Safety Evaluation Report Supporting the
Renewal of the Facility Operating License for the
Washington State University Modified TRIGA Nuclear Reactor
License No. R-76
Docket No. 50-027

September 2011
Office of Nuclear Reactor Regulation
U.S. Nuclear Regulatory Commission

Figure 6.1 Facility organization

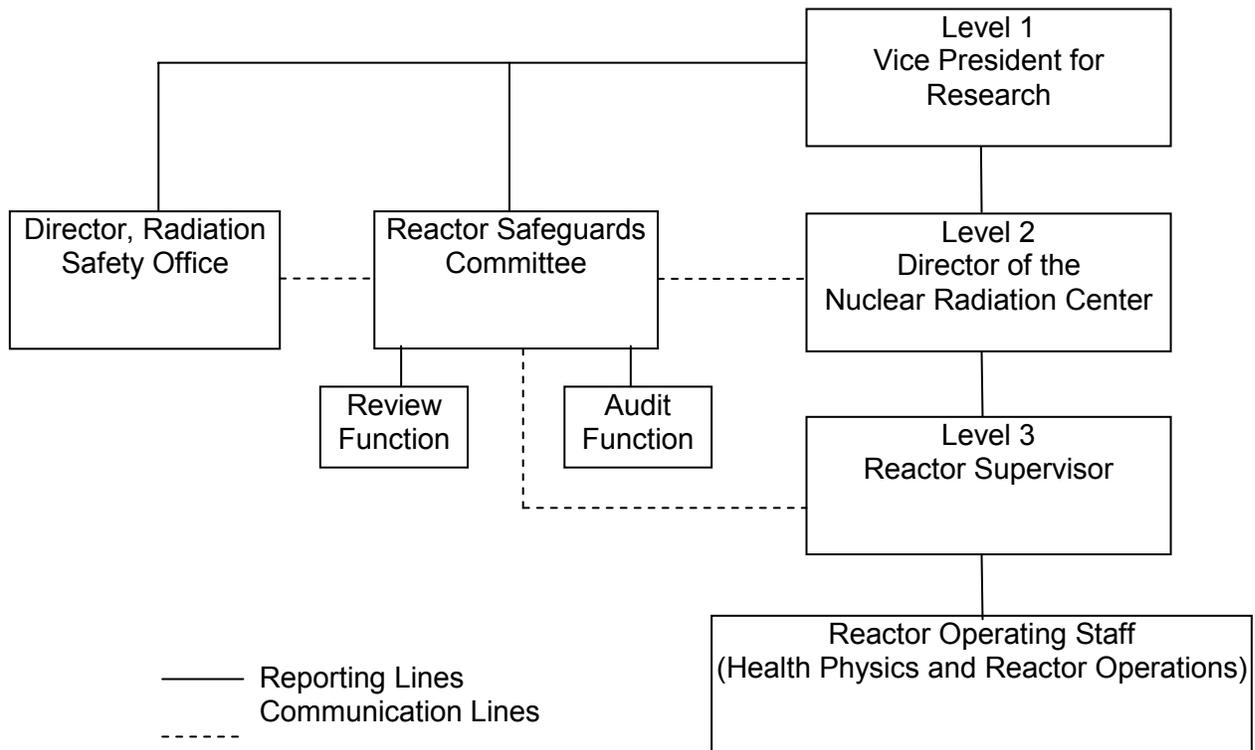
The licensee has modified TS 6.1 to include both the responsibilities and organization of individuals associated with the facility. TS 6.1 has been modified to clearly show the organizational arrangement for the radiation protection function. The licensee also modified Figure 6.1 to correct typographical errors and to identify the reporting and communication relations between the organizational units. TS 6.1 describes the organization and responsibilities of individuals in direct control of the facility and is consistent with the guidance provided in NUREG-1537 and ANSI/ANS-15.1-2007 and is therefore, acceptable to the NRC staff.
